STAFF MEMORANDUM

Meeting Date: **Wednesday, June 9, 2021**

TO: Urban Design Commission

SUBJECT: Additional Review Information

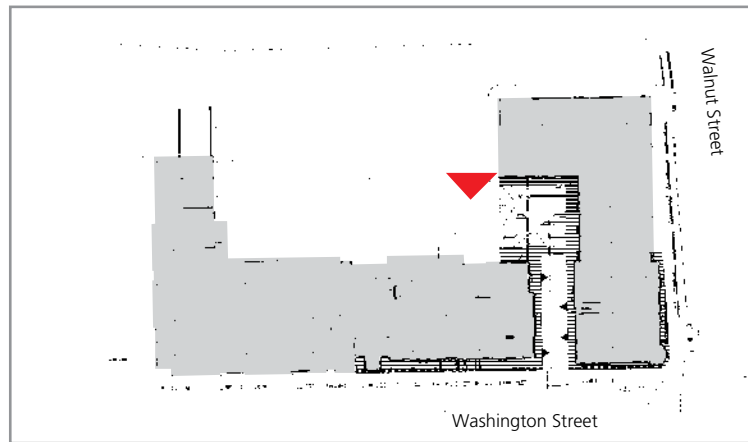
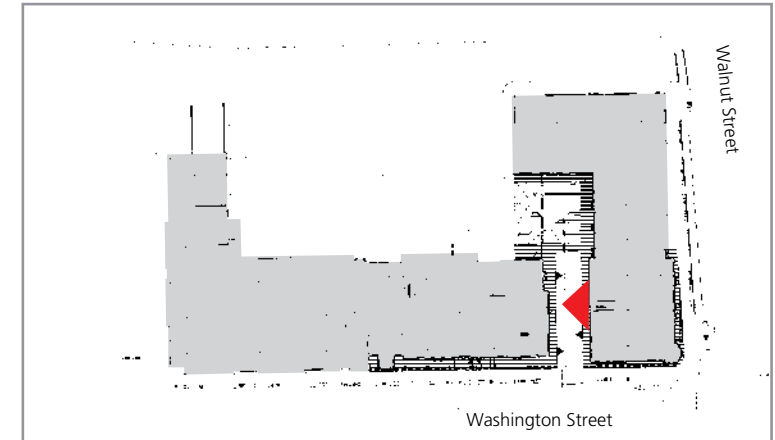
- The proposed blade secondary sign appears to be not consistent with the dimensional controls specified in §5.2.8 and the comprehensive sign package approved by UDC (attachment A). Staff encourages the applicant to explore an option for a window sign for George Howell.
- Clover Food Lab. has 4 signs approved by UDC (signs L1, L2, L4, and L6 as shown in the packet document).

SHEET NO:
A-5.1
EXTERIOR ELEVATIONS
FILE: 1411_A-5.1.dwg

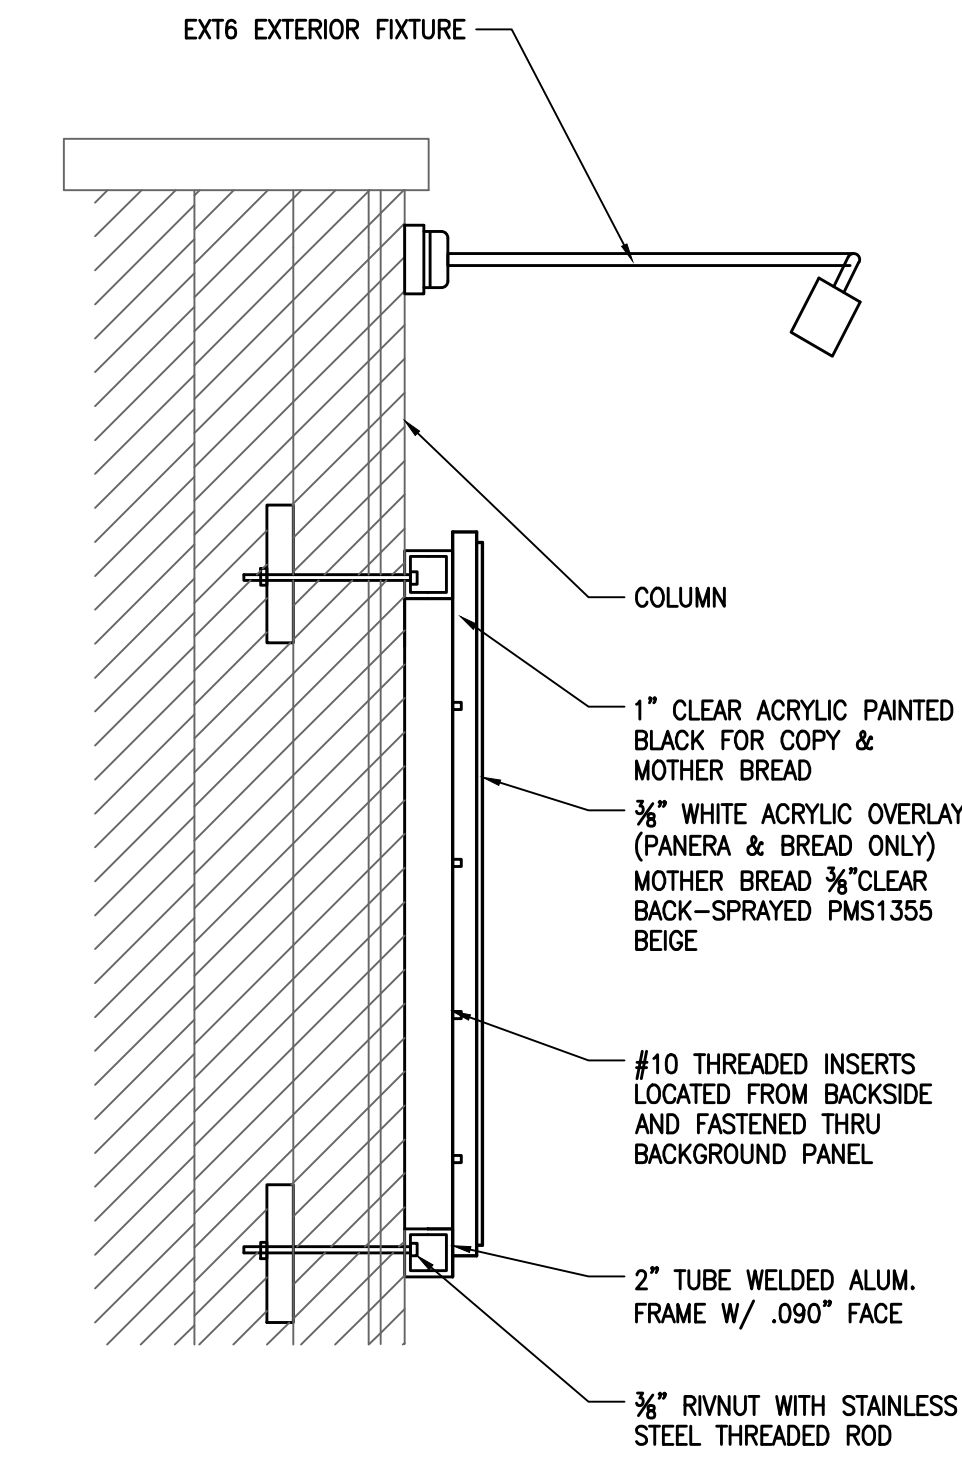
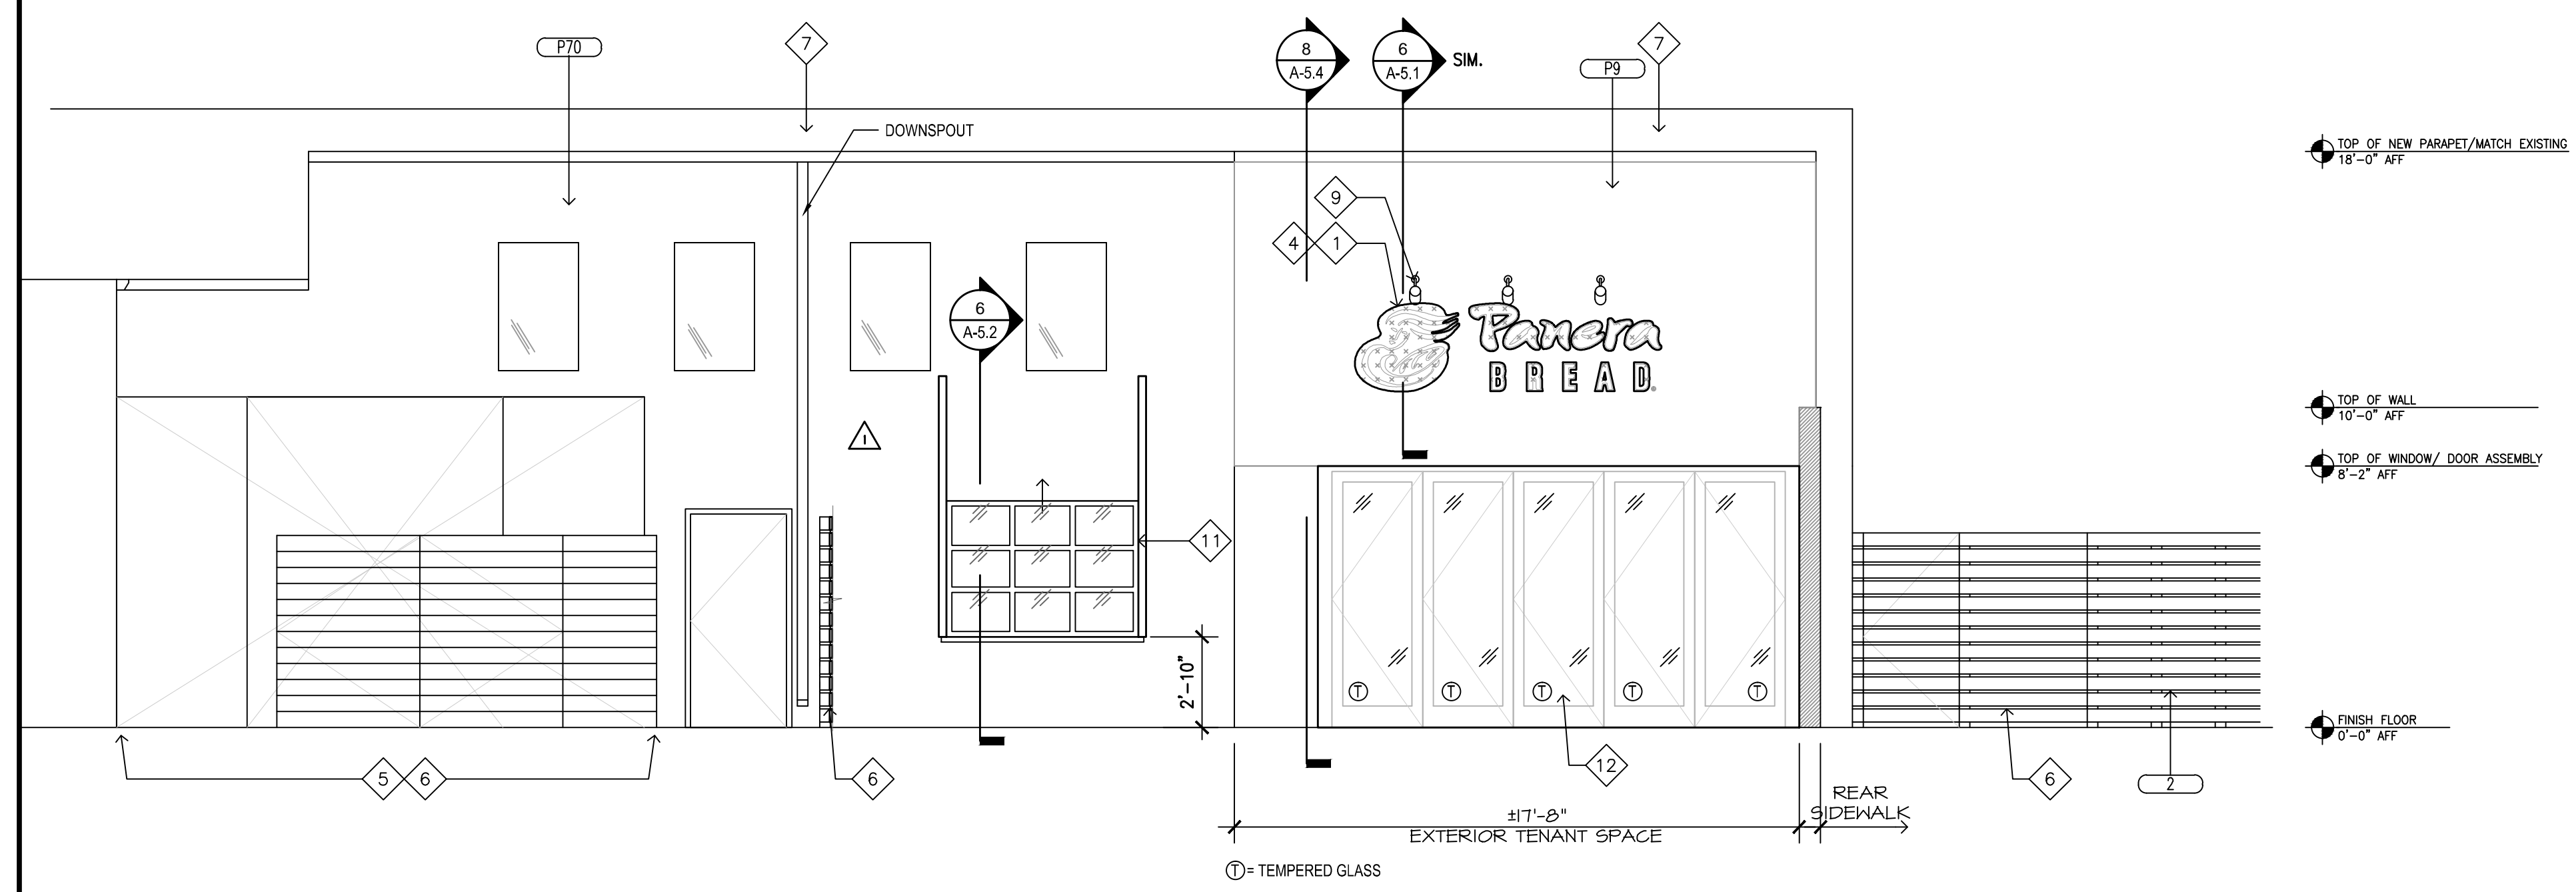
- Both the proposed split principal signs appear to be consistent with the dimensional controls specified in §5.2.8. Per Zoning Ordinance §5.2.8, *“In particular instances, due to the nature of the use of the premises, the architecture of the building, or its location with reference to the street, the total allowable sign area may be divided between two wall signs which together constitute the principal wall sign.”* Per the Zoning Ordinance, one principal sign is allowed, which the applicant is not exceeding, and on this façade of 42 feet, the maximum size of the sign allowed is 100 sq. ft., which the applicant is also not exceeding.
- The proposed secondary sign appears to be consistent with the dimensional controls specified in §5.2.8. Per the Zoning Ordinance, two secondary signs are

allowed, which the applicant is not exceeding, and on this façade of 17 feet, the maximum size of each sign allowed is 17 sq. ft., which the applicant is also not exceeding.

- As per Board Order #242-09 condition #5 *“Any changes to approved signage shall be reviewed by the Urban Design Commission and the Director of Planning and Development.”* (Attachment B)
- All the window signs appear to be less than 25% of window area and are allowed by right.
